Response to Comments

10 CFR Part 20.302 Application

Disposal of Magnesium-Thorium Slag Material

Salzburg Landfill Disposal Facility

Dames & Moore
Figure 3.7-2
Rev. 1
11/25/91

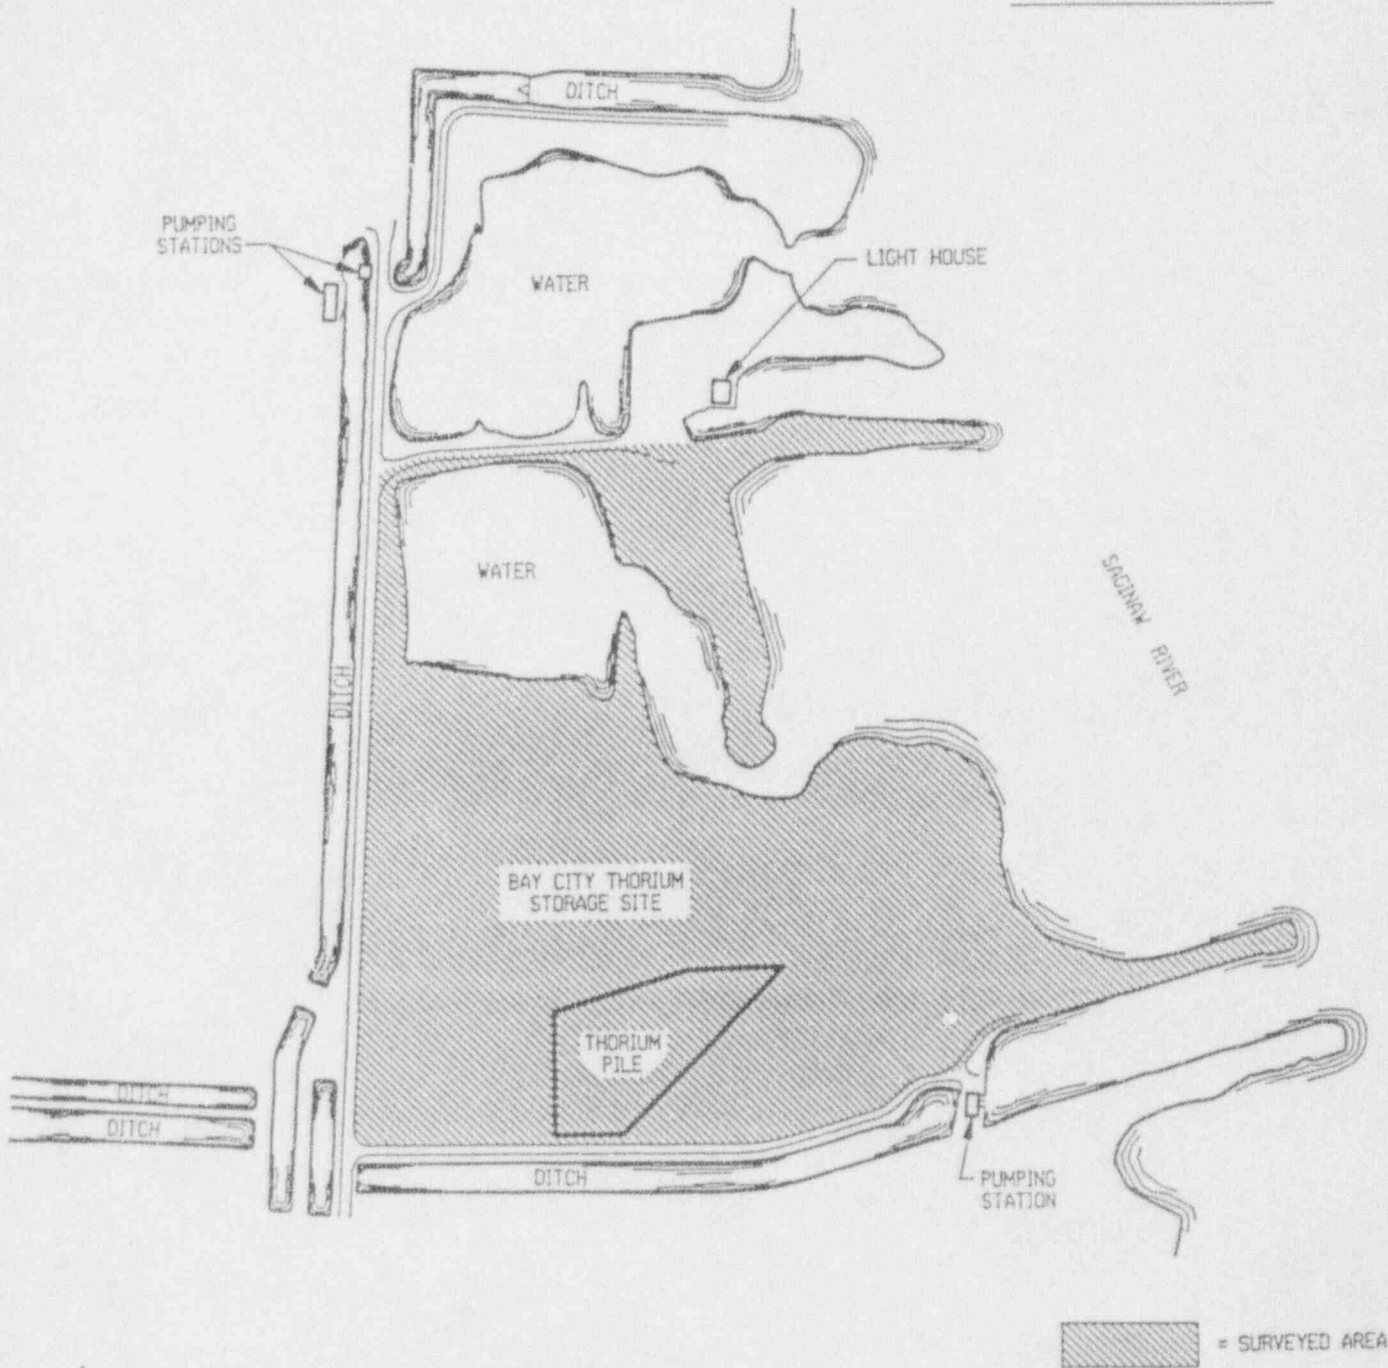
Section 3.8 and Figure 3.7-2 Figure 3.7-2 shows, by cross hatching, the location of the contaminated area at Bay City. This cross-hatched area stops at the fenceline to the east of the slag pile shown in the figure. This is inconsistent with the text in Section 3.8 that states that contamination exists outside of the fence to the east. The application should clarify this discrepancy by either correcting the text and/or figure appropriately, or by explaining why surveying will not be conducted to the east of the fenceline where contamination is known to exist.

Replace Figure 3.7-2 with the attached Figure 3.7-2 (Rev.1), entitled
"Location of Magnesium/Thorium Storage Site (Bay City, Michigan)".

The map in Figure 3.7-2A will replace Figure 3.7-2 in the text (see errata). It shows the extent of the region now surveyed at Bay City and reflects the results of an extensive survey of the site. There are discrete areas of elevated thorium that have been located outside of the fence. The results of the survey will be used as the starting point for the excavation, with all elevated material inside and outside the fence removed to the required cleanup levels.

Figure 1

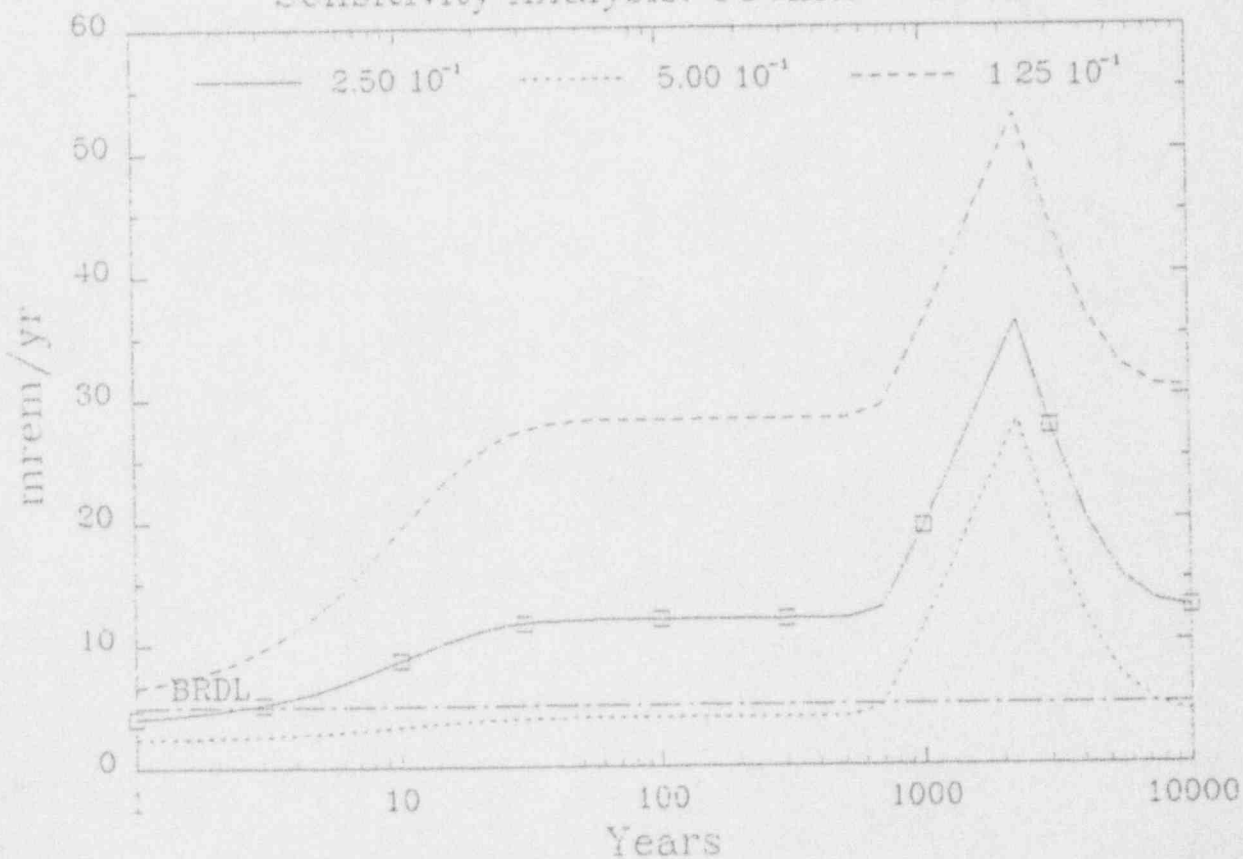
Section 1.1 The current NRC soil clean-up standard for thorium is the Branch Technical Position on burial or on-site storage of uranium and thorium waste (46 FR 52061). The licensee must show that the proposed thorium (and daughter) concentration of material to be left in-place will not give a dose over a few mrem/yr total effective dose equivalent (TEDE).

In response to the comments herein, and discussions with NRC personnel, calculations have been performed of TEDE for an intruder scenario with the hypothetical condition of no soil layer over the residual material. Both the MAXI and RESRAD models were used to perform these analyses. In reality clean soil will be emplaced over the residual material to restore the site. The postulated scenario of loss of this cover due to long-term erosion taken together with the consideration that institutional control over the site will be eventually lost permitting intrusion to the residual material makes it essentially impossible to achieve a TEDE of less than "a few mrem/yr" (see below). This unrealistic combination of factors would require reduction of residual concentrations to less than 1 pCi/g Th-232 above background at the site (and any other site containing thorium). As discussed below, the more realistic assumption of the maintenance of a minimal clean fill of 10" over the residual material would reduce long-term total dose to about 10 mrem/yr; or, the presumption of continued control over site access would eliminate the presence of the intruder.

Figure 2

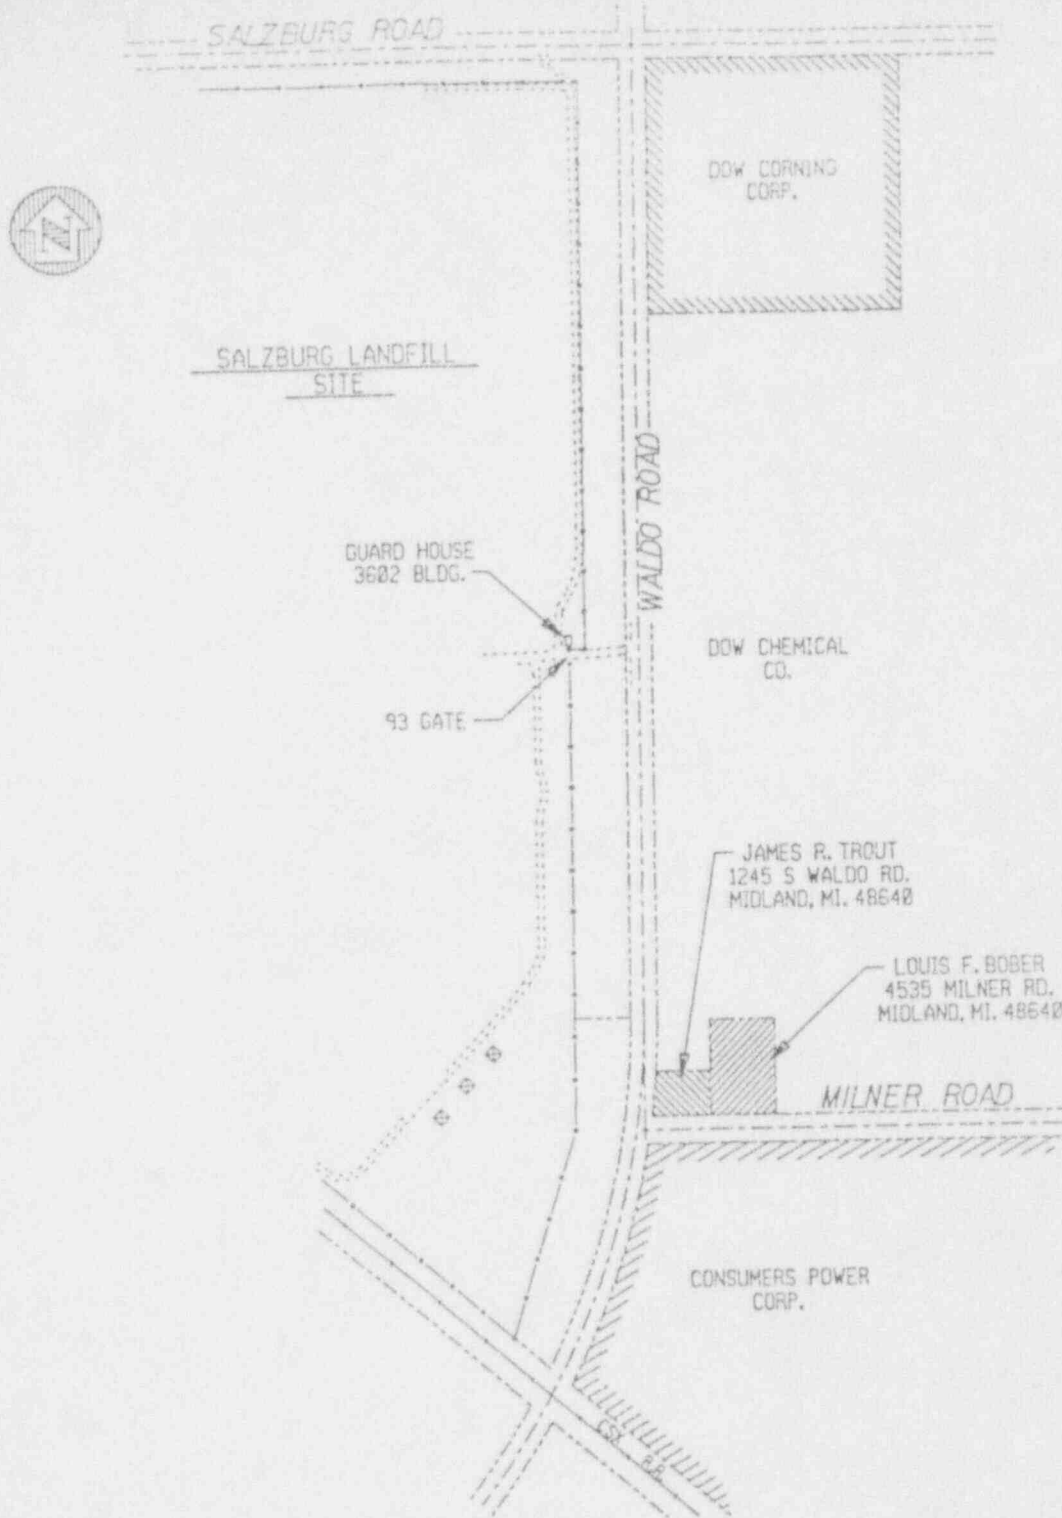
Section 5.3.1 Figure 5.3-2 indicates that the "Generalized Development Plan" calls for this land to be designated as industrial. The text also states that the "Midland Township Zoning Ordinance has the property adjacent to the site zoned residential [but that this] should only be considered a temporary zoning designation, since the Township Master Plan proposes this property be developed as industrial in the future." It is also indicated that this information was current in 1984. The application should contain the most recent information on the zoning designations for the lands adjacent in all directions to the Salzburg Landfill. Also, the application should contain additional information on the actions that will be taken to implement either the "Generalized Development Plan" or the "Township Master Plan" that will lead to an industrial zoning designation for the lands east of the Salzburg Landfill.

Dow continues to purchase the residential property east of the Salzburg Landfill adjoining Waldo Road and Milner Road. Currently the only residences not owned by Dow are the Trout and Bober residences, as shown in the property ownership sketch of Figure 2.0. Dow continues to pursue the purchase of these properties as they become available and conversion of the zoning of all the existing residential property to industrial.

Figure K-2

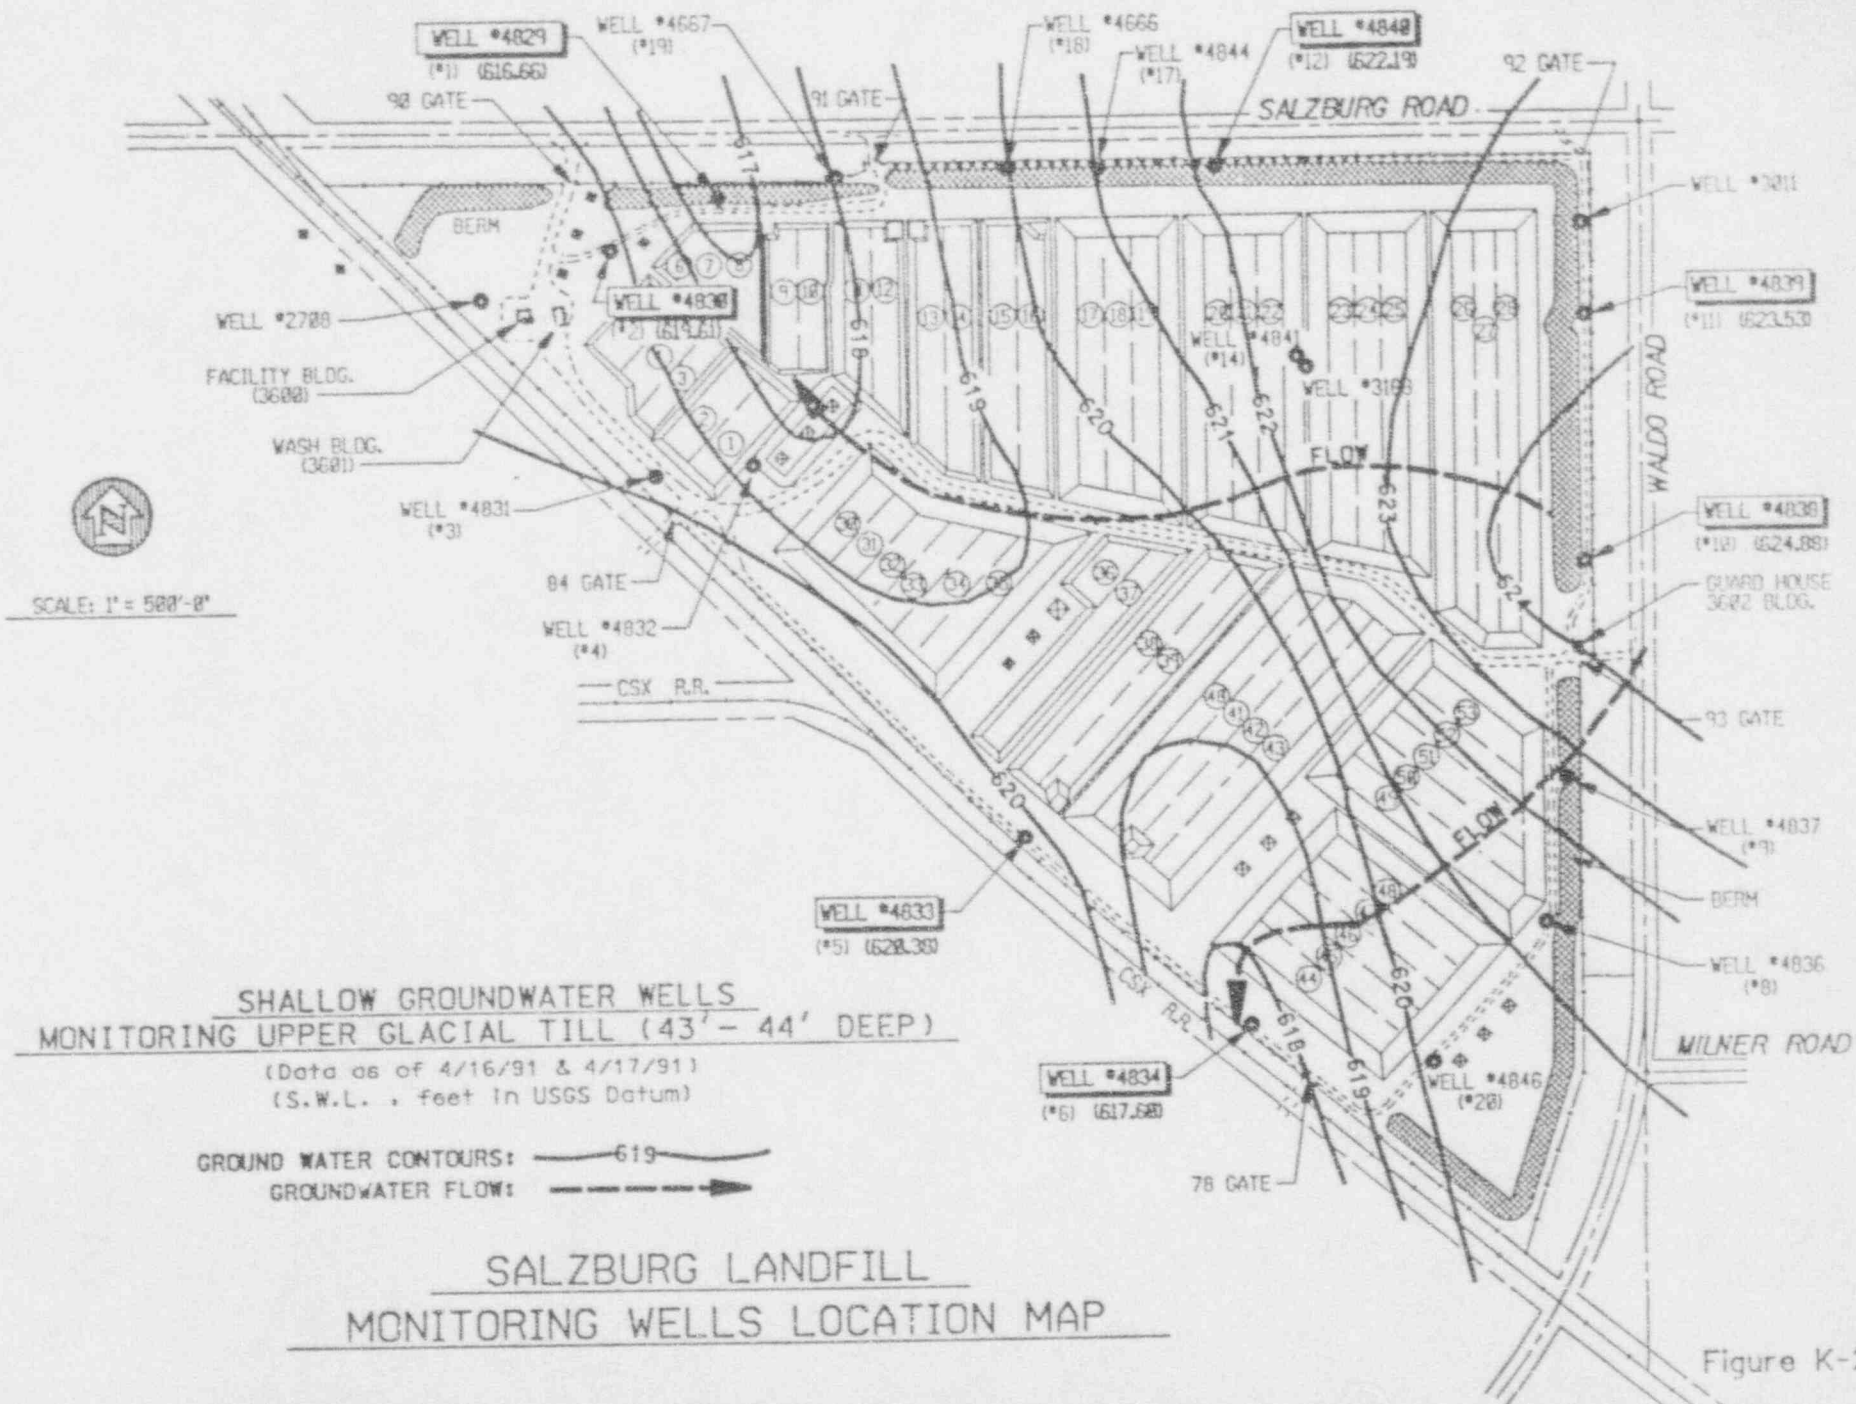
Section 7.4.2 The I.D. numbers for the well locations shown in Figure 7.4-2 are either illegible or missing.

Figure 7.4-2(A), titled "Salzburg Landfill Monitoring Wells Location Map" shows the monitoring wells with their I.D. numbers. It is included with the text corrections in the errata.

The next deeper zone contains those monitoring wells screened 43 to 44 feet below grade (Figure K2.0). This zone of wells is the only group of wells in consistent sediments (i.e., clay Glacial Till) that can be contoured and provide reasonably realistic gradients. The general flow is toward the west, with a southerly flow at the southeast corner of the landfill.
